**Clinton County Planning Commission**  
**July 16, 2024 - 7:00 PM**

- Land Development Plans
  - Land Development – Taco Bell Restaurant, Borough of Flemington

# PRELIMINARY/FINAL LAND DEVELOPMENT PLAN PROPOSED RESTAURANT - "TACO BELL - TRINITY HOLDINGS" CLINTON COUNTY 559 HIGH STREET FLEMINGTON BOROUGH, PA 16101 TAX PARCEL: 11-5628-9, PENNDOT APPLICATION: SR 0150, SEGMENT 0190, OFFSET 990

**DEMOLITION**  
**PLAN**  
**C1.0**

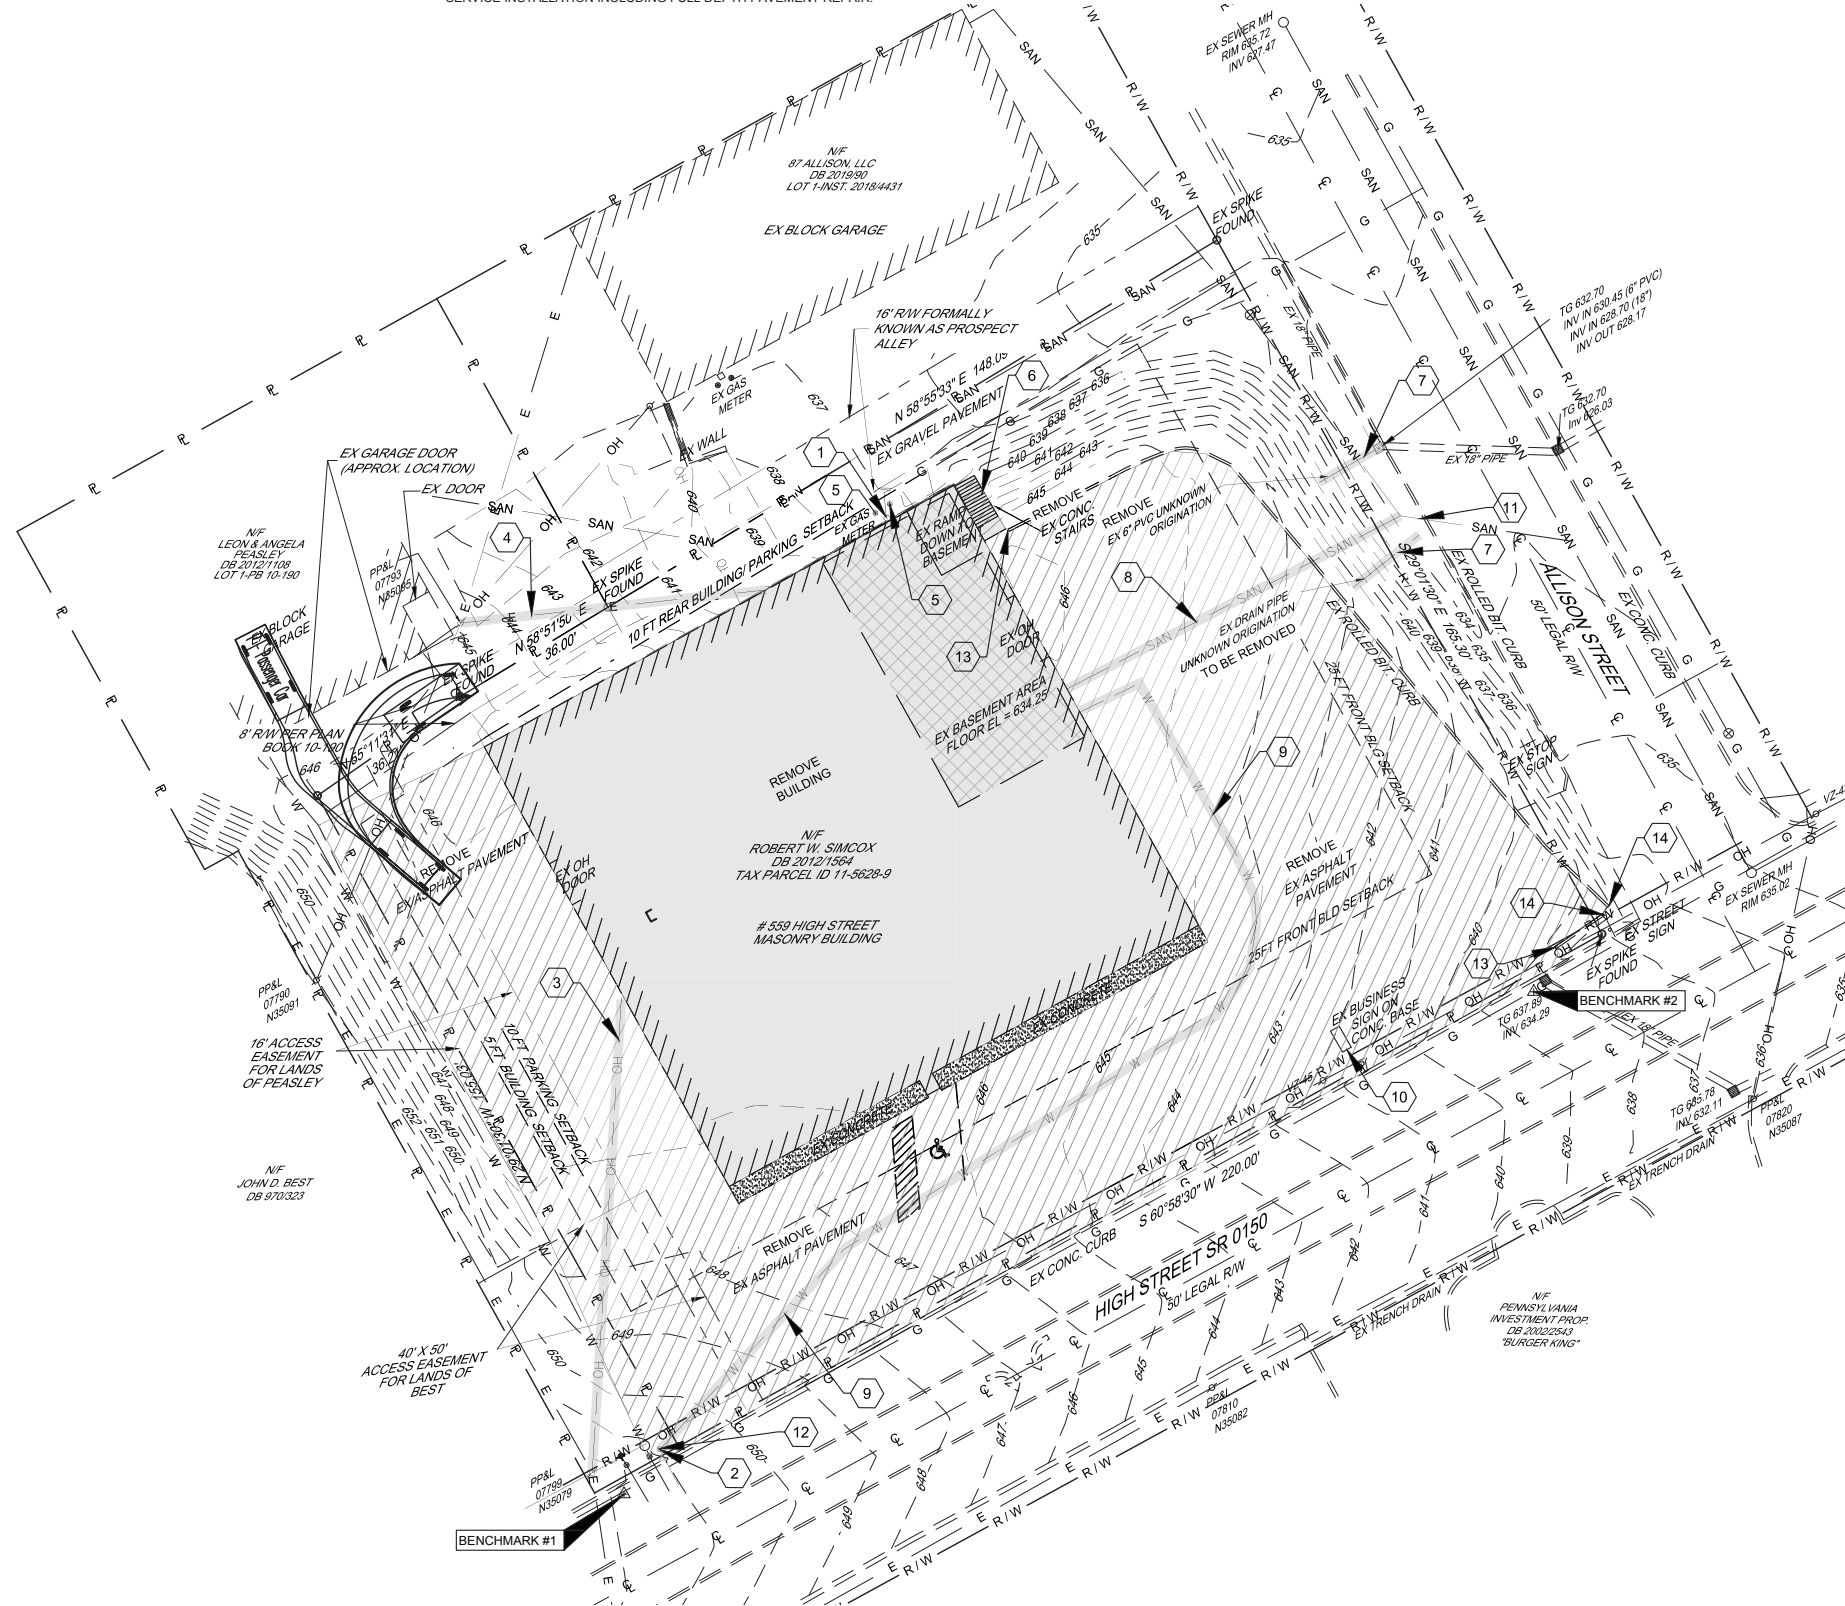
- Easements – comment on access only. Currently the RW is being used to park cars.
- Require a demolition permit from the Borough.
- Note 11 – cannot share a lateral with other private properties. A new connection must be made to the existing sewer main in Allison Street.
